RE: **6-DR-2021**

DC Ranch Parcel T7 (Arcadia) - Sisso Tree Removal
86H76 (Key Code)

The Planning & Development Services Division has completed the review of the above referenced development application submitted on 2-17-2021. The following **1st Review Comments** represent the review performed by our team and is intended to provide you with guidance for compliance with city codes, policies, and guidelines related to this application.

FIGURE 5-3.26 INTERSECTION DEPARTURE SIGHT DISTANCE REQUIREMENTS

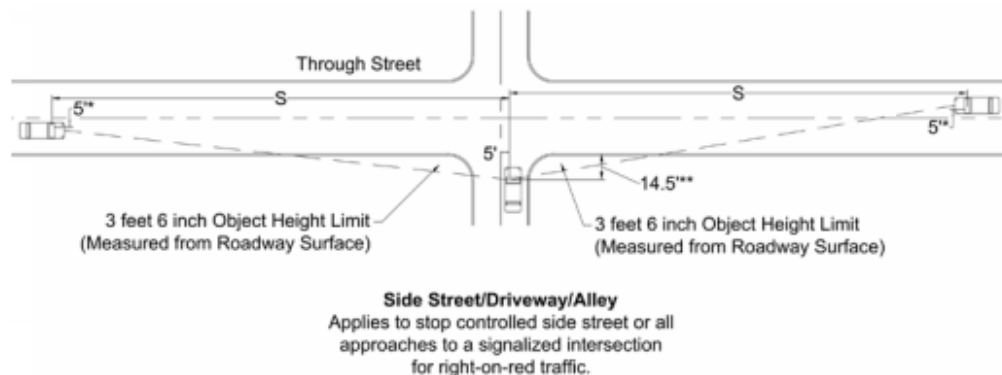
12. Please update the project narrative and provide a graphic identifying and confirming any proposed tree plantings near street intersections the safety triangle and sight distance must be shown on the plans; tree canopies must be trimmed to 7 feet if within these areas (DSPM Section 5-3.123; Figure 5-3.27; DSPM Section 5-3.123; Figures 5-3.25 and 5-3.26) [the graphics have been updated with additional clarity and notes to this effect.](#)

13. Provide updated material that identify, dimension, and label public utility easements within planting site plan + confirm no trees are being planted within these easements (DSPM Section 3). [The easements have been clearly labeled and dimensioned. A note has been added to the plans that no tree will be planted within the easements. Additionally, the Plat contains](#)
14. Update planting site plan with required site distance triangles meeting the requirements of these intersection sight distance requirements and confirm no trees are being planted within these triangles (these are in addition to the SVTs that are currently shown (DSPM Section 5-3.123.D)) [The trees triangles per the DSPM have been added to the Landscape Plan](#)
